CITY OF ALBUQUERQUE

May 4, 2020

RE: **Lot 1 Block 2 Unit 27 SAD 228
5508 Valiente Rd NW
Volcano Cliffs Subdivision
Grading and Drainage Plan
Engineers Stamp Date 4/24/2020 (C11D005)**

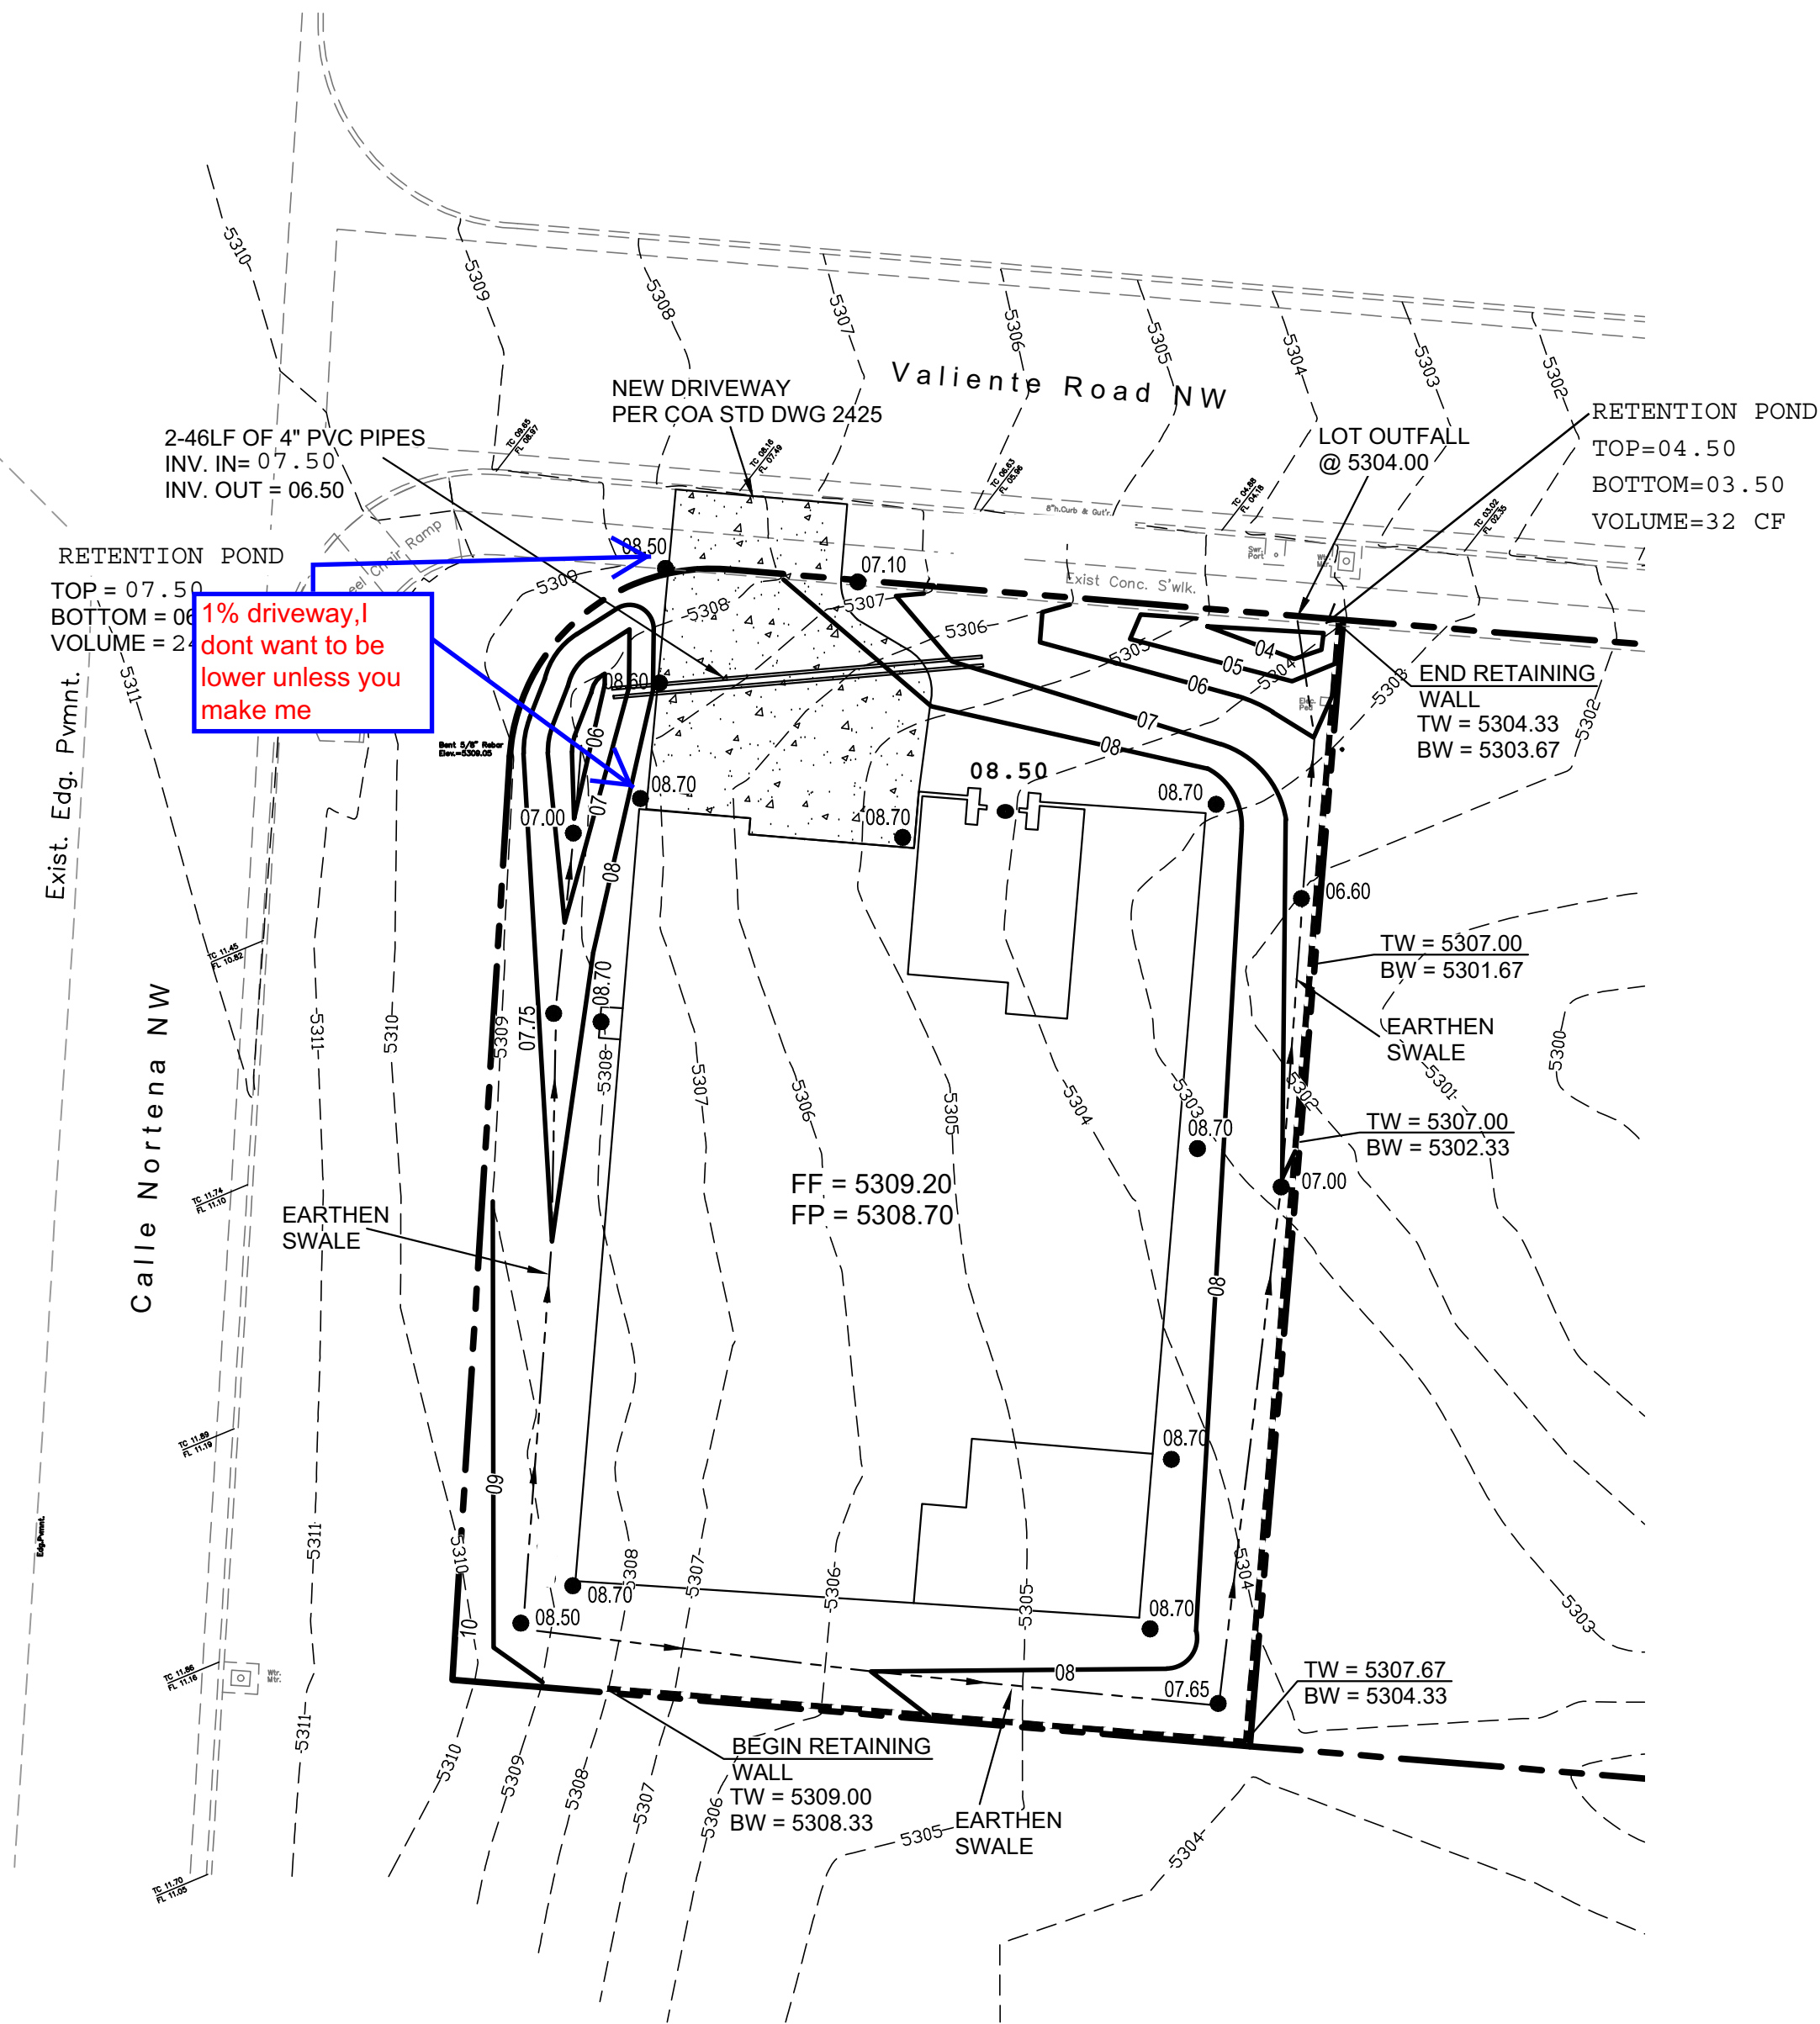
Based upon the information provided in your submittal received 4/29/2020, this plan is approved for Grading Permit.

Prior to Building permit approval a Pad Certification will be required, provided by the Engineer or a registered Land Surveyor.

Advise the owner contractor not to use dirt as a ramp to climb the curb, use lumber or crusher fines for this purpose.

Reiterate to the Owner/Contractor that a separate permit for a garden/retaining wall must be obtained with the approved G&D plan and Pad Certification. Also, if a swimming pool is to be placed the grading and drainage plan will change and will need to be resubmitted.

Prior to Certificate of Occupancy release, Engineer Certification per the DPM checklist is required.
